PROJECT
**240 COUNTY ROAD, 4 BATH
ONTARIO, KOH IGO**

CLIENT
**LOYALIST TOWNSHIP - MILLHAVEN
ADMIN BUILDING**

DRAWING
**STANDARD & UNIVERSAL
WASHROOM DETAILS**
ADDENDUM COMMENTS

REVISIONS		
NO	ITEM	DATE
1	ISSUED FOR SPA	02-25-2026
2	ISSUED FOR CONSULTANT REVIEW	04-01-2026
3	ISSUED FOR CONSULTANT REVIEW	05-25-2026
4	Addendum adjustments	07-20-26

1 UPPER REFLECTED CEILING PLAN
SCALE: 3/16" = 1'-0"

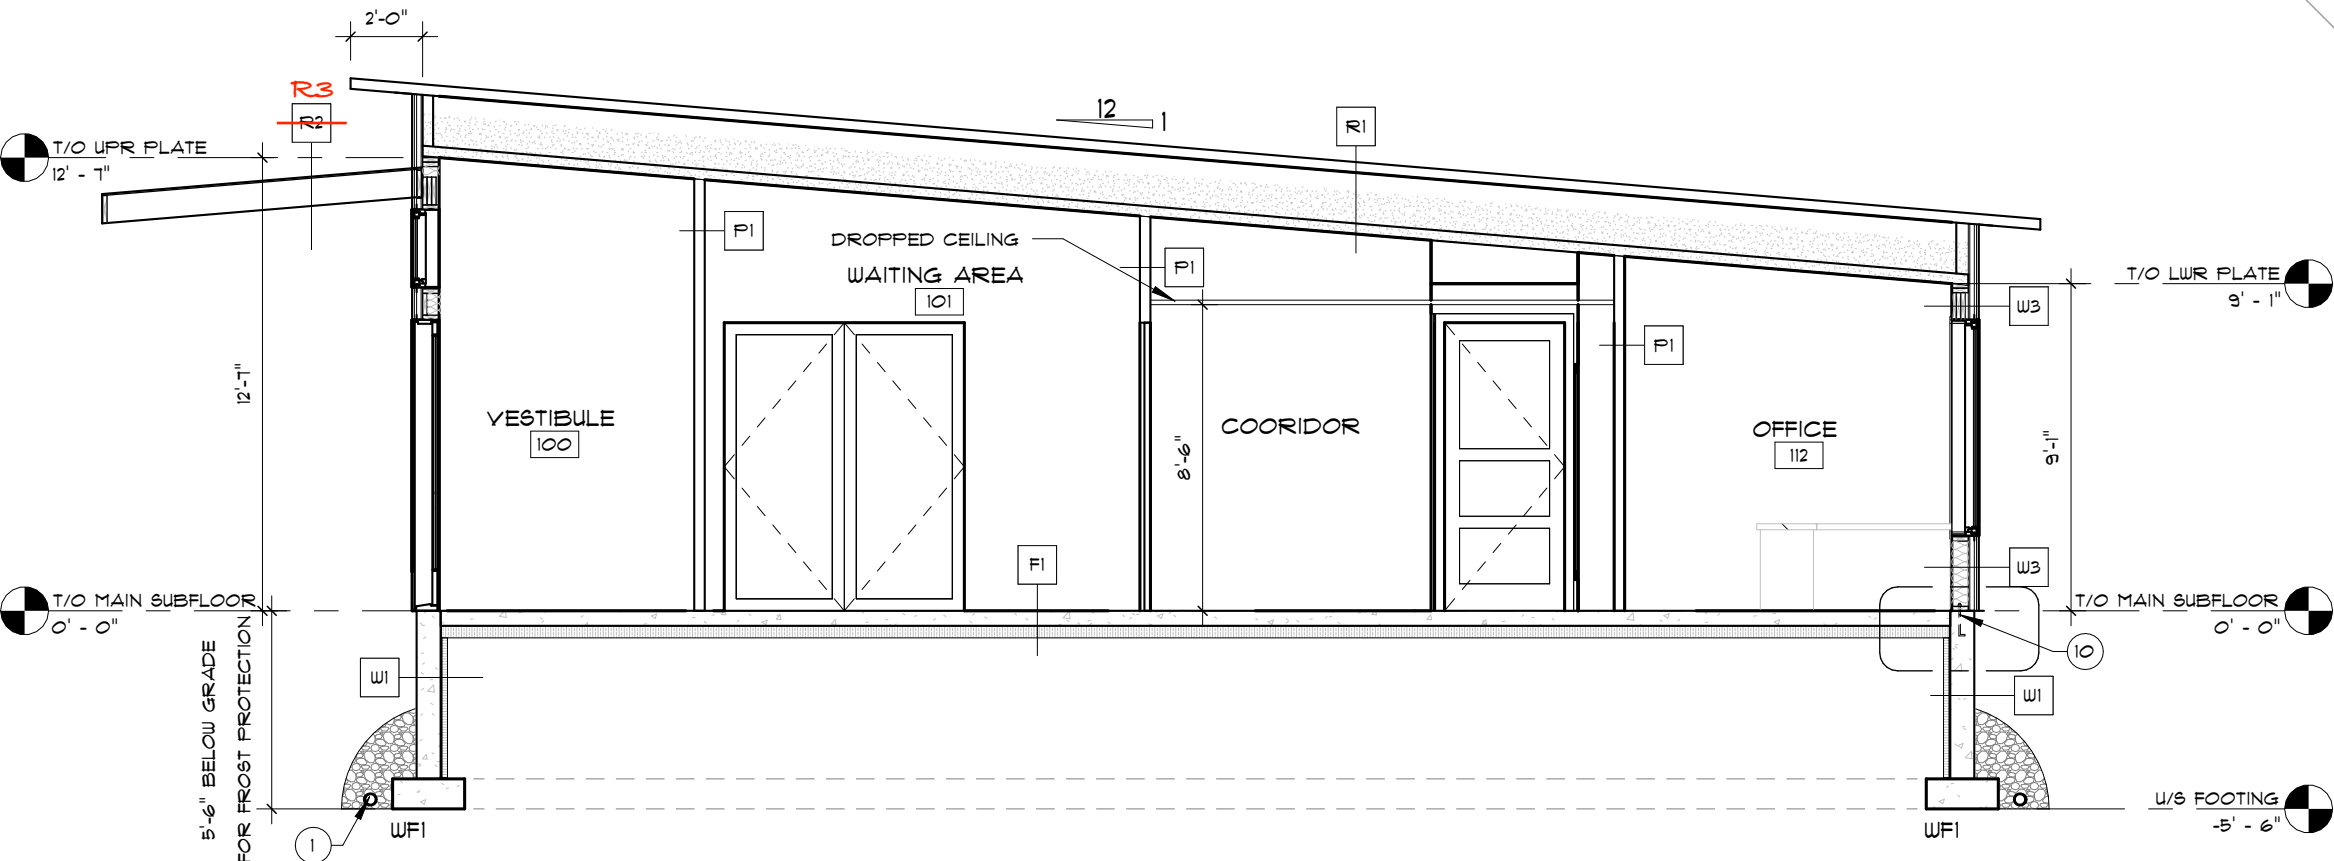
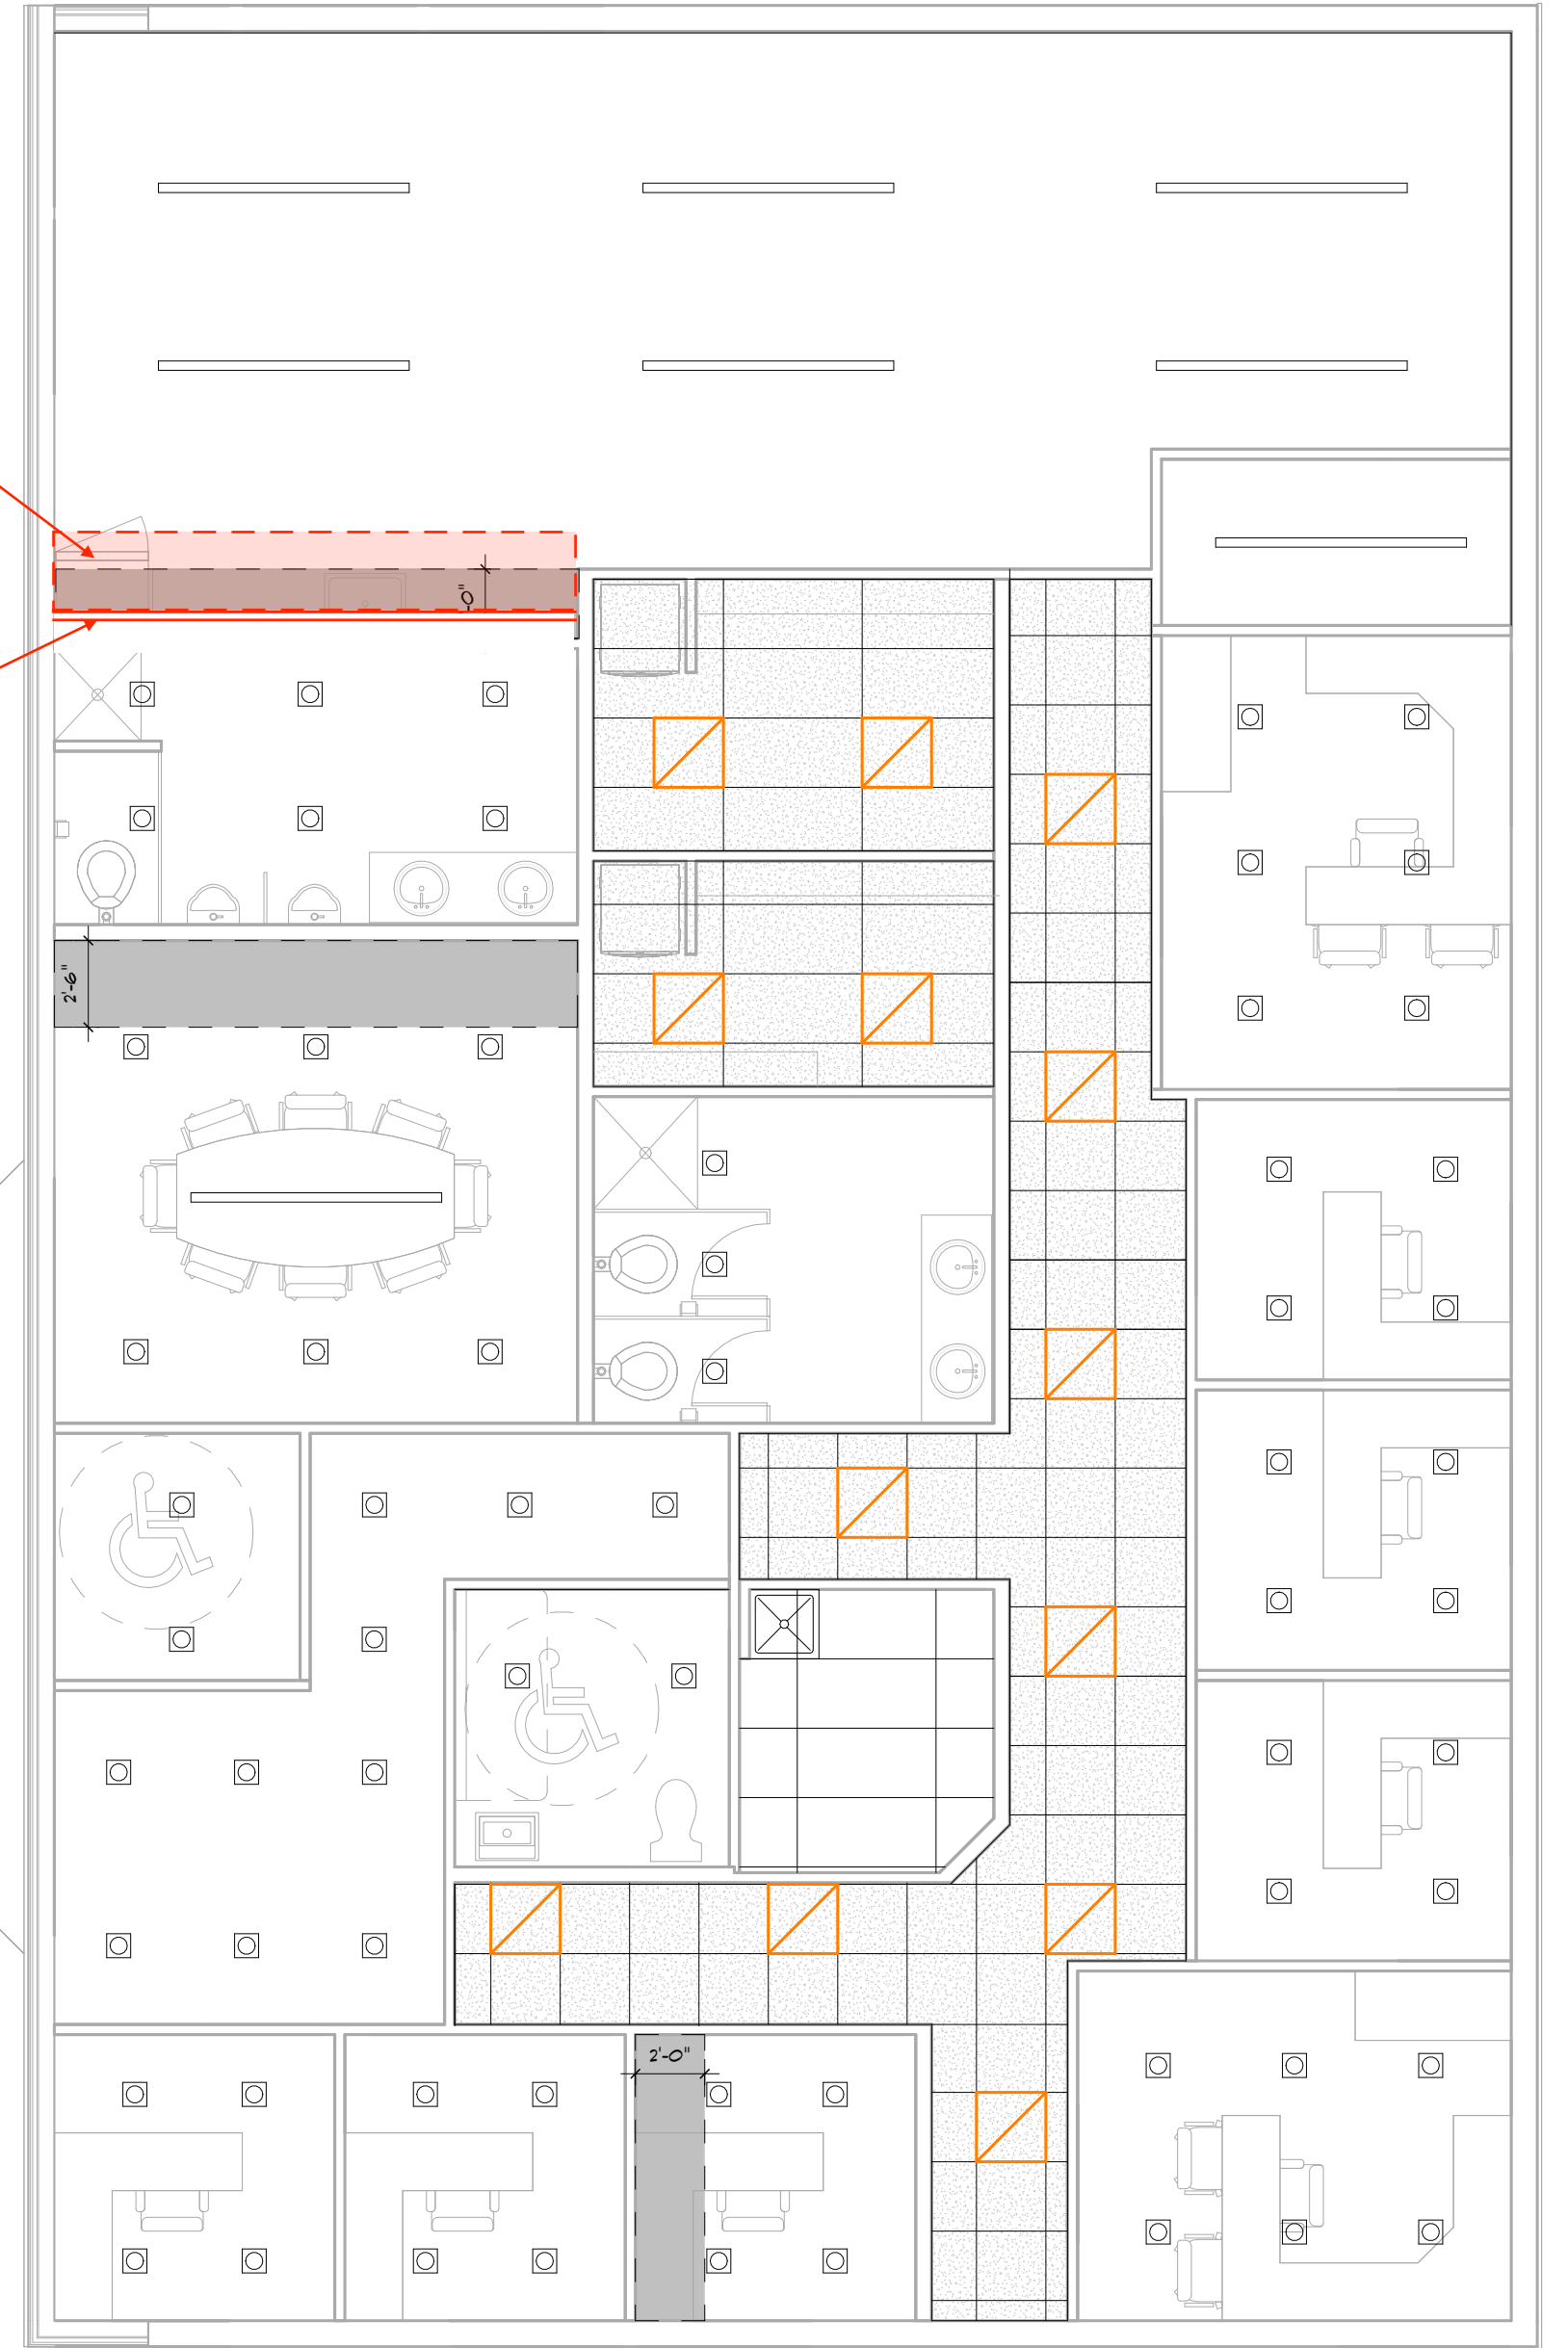
move bulkhead 12"
Move wall 12" as per plan A.3
